WEB CUTTING DIAGRAM FOR 16G5A

MEGQUIER & JONES INC.

PAIN	HOLES U N	WELD U N	Q C REVIEW
PROJECT	TH NO. 1 OVER THE GIRON RIVER PROJECT NO. BHO 1448 (29) BRIDGE NO. 5 TOWN OF JOHNSON, VERMONT		DATE 6-4-09
DESCRIPTION	CAMBER DIAGRAMS		DRAWN BY R.L.K. 5-22-09
ARCH	N/A	ENGR VERMONT AGENCY OF TRANSPORTATION	CHK'D BY GDC
CUSTOMER	S.D. IRELAND CONCRETE CONSTRUCTION CORP.		JOB NO J-81
			SHT NO 5

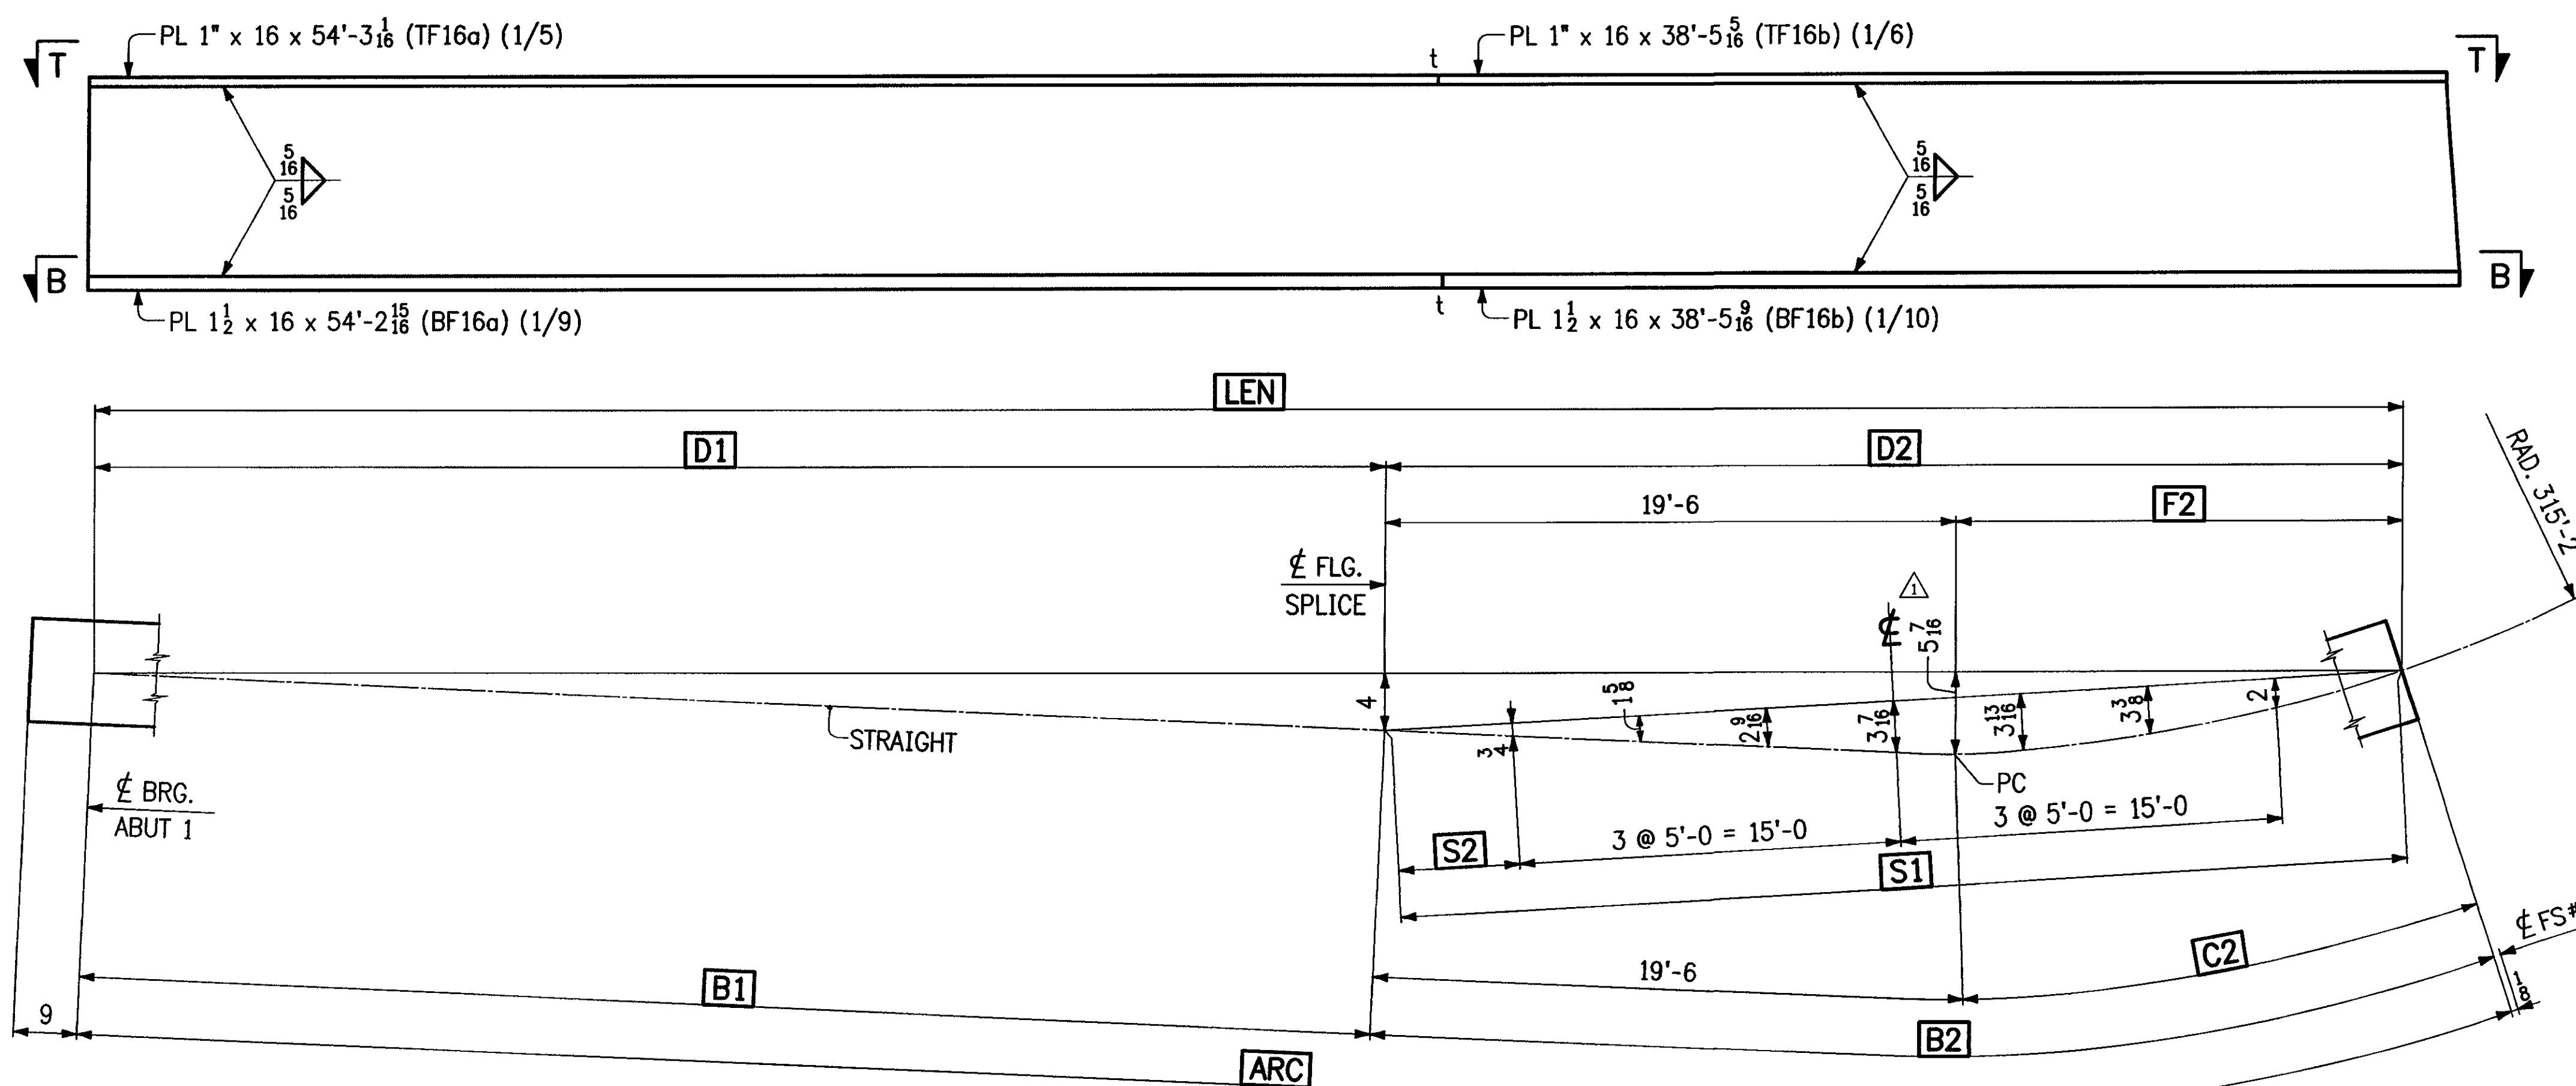
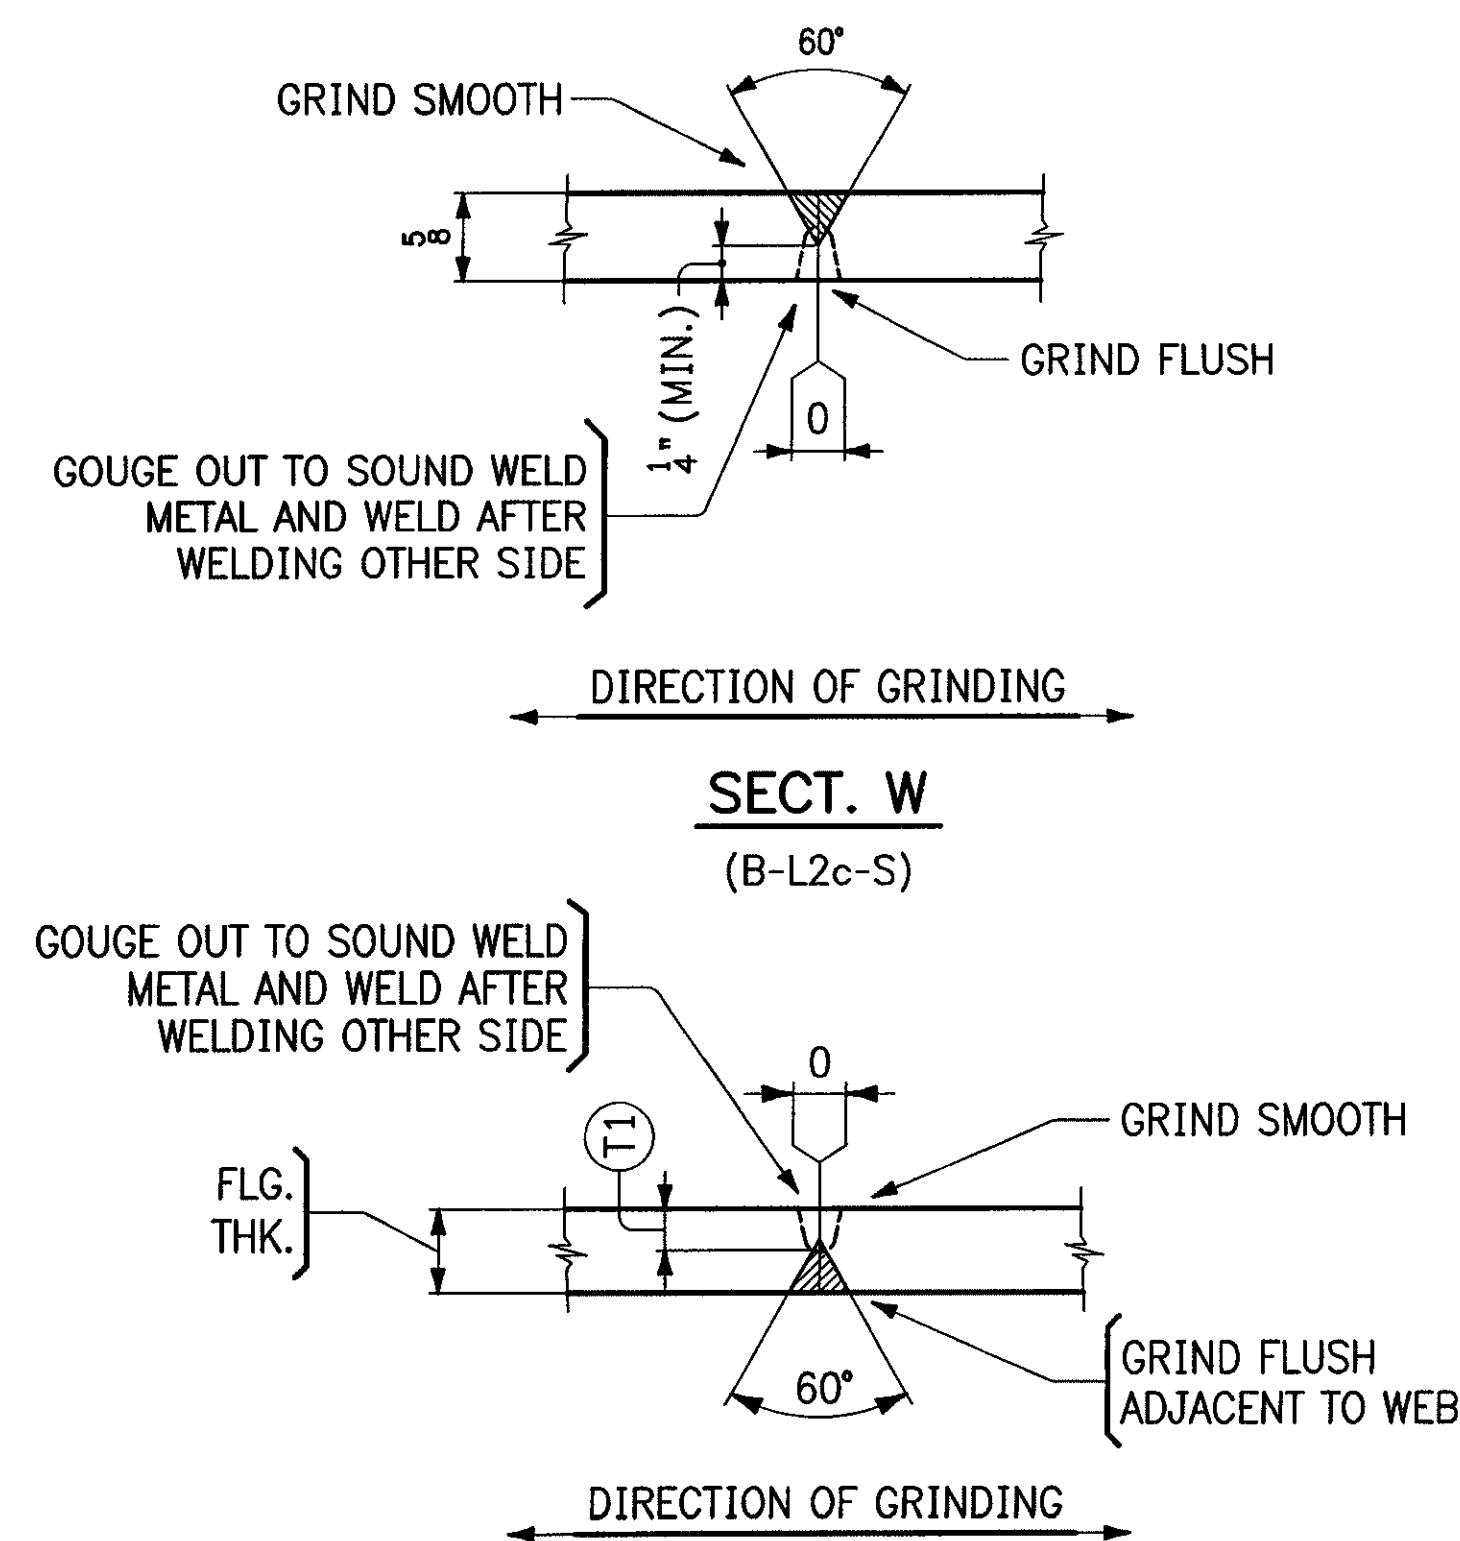
REVISIONS			PRINT RECORD		
NO	DATE	DESCRIPTION	DATE	QTY	ISSUED
			7-16	5p	Appr.
7-14-09		REVISED HORIZONTAL CURVING DIAGRAM.
